Request for Class II Permissive Change

FCC ID: VG8EM720DXX

Data: 2012-11-20

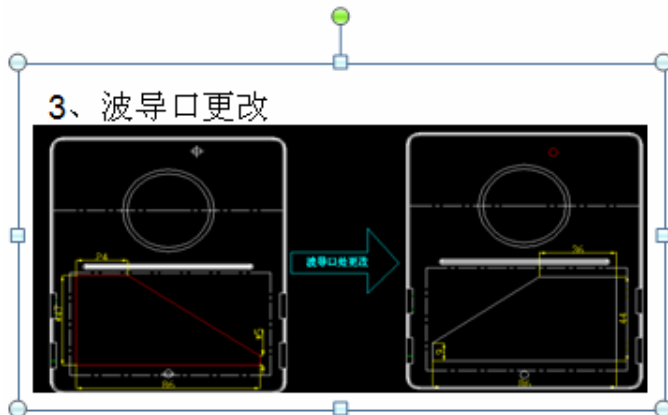
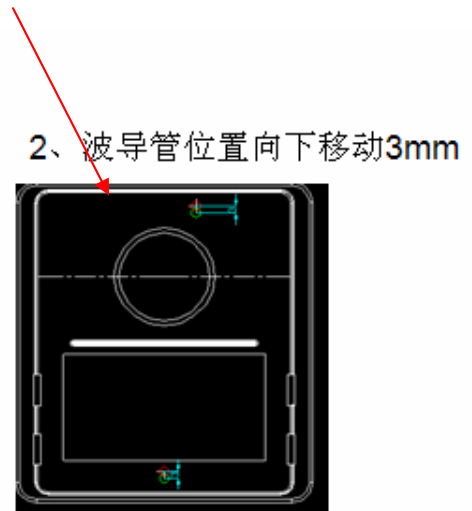
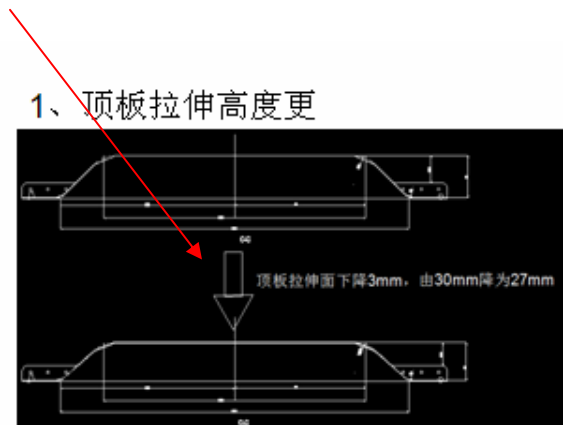
1.Top roof dropped 3mm from 33mm to 27mm.

2. The waveguide tube position moved down 3mm.

3.The Waveguide position has changed.
